Access Compliance Report

Public Rights-of-Way

Intersection ID: 30036	Main Street: KEMPSFORD_DR	Cross Street: ROCHDALE_LN	Location: SW
ADA ID: 04DD0A8E6596	Ramp Type: PerpDiag	Initial Pass/Fail: Fail	Overall Compliance: No
		Severity Score: 10

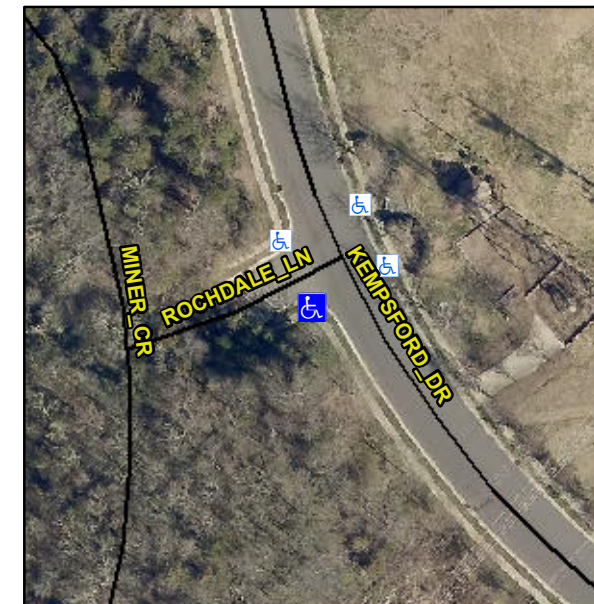
R304.5.1, R304.5.3

Compliance	Description	Data	Compliance	Description	Data
N/A	Ramp Length (in)	51.0	Yes	Ramp Slope (%)	6.5
No	Ramp Width (in)	47.5	No	Ramp XSlope (%)	3.0
N/A	Flare Type LT	N/A	N/A	Flare Type RT	N/A
N/A	Flare Slope LT (%)	N/A	N/A	Flare Slope RT (%)	N/A
N/A	Flare Traversable LT?	N/A	N/A	Flare Traversable RT?	N/A
N/A	Landing Length (in)	N/A	N/A	DWS Provided?	N/A
N/A	Landing Width (in)	N/A	N/A	DWS Contrast?	N/A
N/A	Landing Slope (%)	N/A	N/A	DWS Length (in)	N/A
N/A	Landing X Slope (%)	N/A	N/A	DWS Full Width?	N/A
N/A	Landing Curb? (Y/N)	N/A	N/A	DWS Offset (in)	N/A
N/A	Shared Landing?	N/A			
N/A	Gutter Ponding?	N/A	N/A	Gutter Slope (%)	N/A
N/A	Gutter Lip Ht (in)	N/A	N/A	Gutter X Slope (%)	N/A
N/A	Painted X Walk1?	No	N/A	Painted X Walk2?	No
	X Walk 1 Direction	To N		X Walk 2 Direction	To E
N/A	X Walk 1 Width (in)	N/A	N/A	X Walk 2 Width (in)	N/A
	X Walk 1 Slope (%)	5.4		X Walk 2 Slope (%)	7.1
	X Walk 1 X Slope (%)	5.4		X Walk 2 X Slope (%)	0.4

Remove & Replace Curb Ramp With Two New Directional Ramps or Equivalent.
